UNITED STATES
NUCLEAR REGULATORY COMMISSION

SUBJECT: REQUEST FOR ADDITIONAL INFORMATION NO 1. (RAI-1) ON THE TOPICAL REPORT ENTITLED, "MULTI-USE CONTAINER HIGH INTEGRITY CONTAINER," CHEM-NUCLEAR SYSTEMS, INC., DATED JULY 23, 1992 (DOCKET WM-107)

REQUEST FOR ADDITIONAL INFORMATION
JANUARY 6, 1994

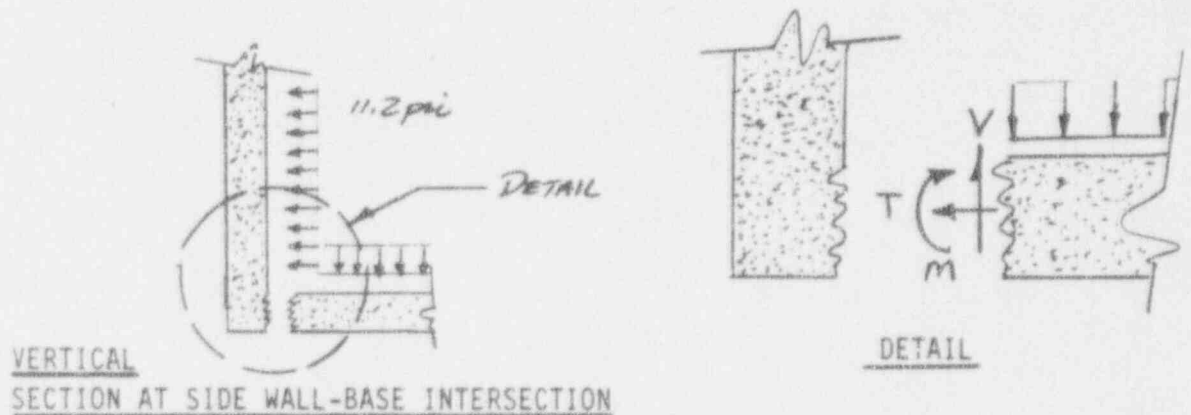
47. Section 3.6.4 beginning on p. 3-14 presents information on the calculations for the 68-inch MUC. The various figures associated with the calculations do not contain an identification of the coordinate axes (Figures 3.6-3 through 3.6-7), yet Figures 3.6-6 and 3.6-7 are representing stresses in the x and the y-directions. In the text various internal forces or stresses are discussed, but the direction and sign conventions are not defined. For example,

it is stated that the maximum bending moment is at the edge and is 2,239 in-lb/in, but it is not defined whether it is an M_x , M_y or M_z moment (at a vertical corner or the side to bottom edge). In Figure 3.6-4 through Figure 3.6-7 there are numerous marginal entries associated with the figures that are undefined. Please provide clarification on the coordinate axes identification, the sign conventions and the identification of marginal entries.
